January 9, 2023

Product Change Notice - X180T controller updates

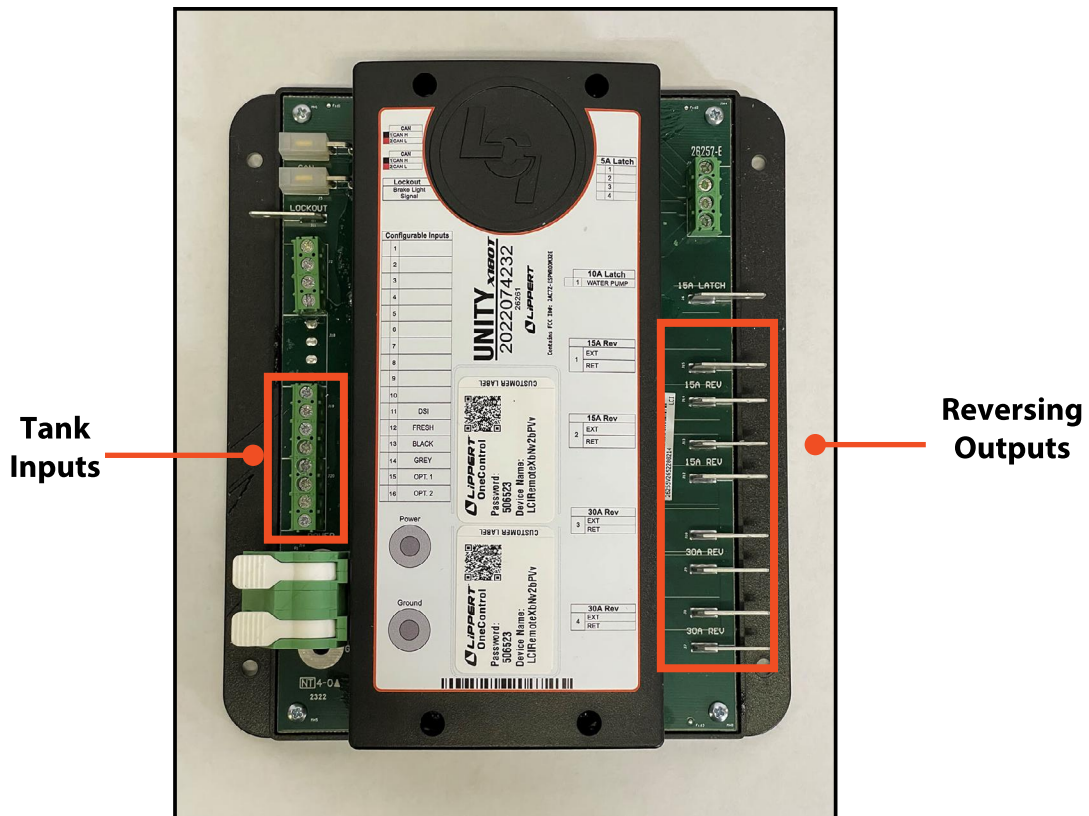
In order to provide a more uniform product we are updating our X180T to a version that accommodates five holding tanks. The current version accommodates four holding tanks.

There are slight differences in installation between the current and new controllers:

- All tank inputs on the left side move up one space.
- In order to provide uniformity across all production lines, all of the reversing outputs on the right side are opposite of the current version. (Extend on top and Retract on bottom now).
- New wiring diagrams will be provided.

- 1. Will a new part number be required?** Yes, the current part number is 2020107939, the new part number is 2022074232. A new quote will be provided.
- 2. Does the price change for the item?** No, there is no price change.
- 3. Is the new part wholly interchangeable with the previous version of the part?** Yes, the controllers are interchangeable as long as the new wiring diagram is followed for the current version.
- 4. Does the customer need to replace inventory?** No, the change will take place on a running basis starting around Jan. 16.
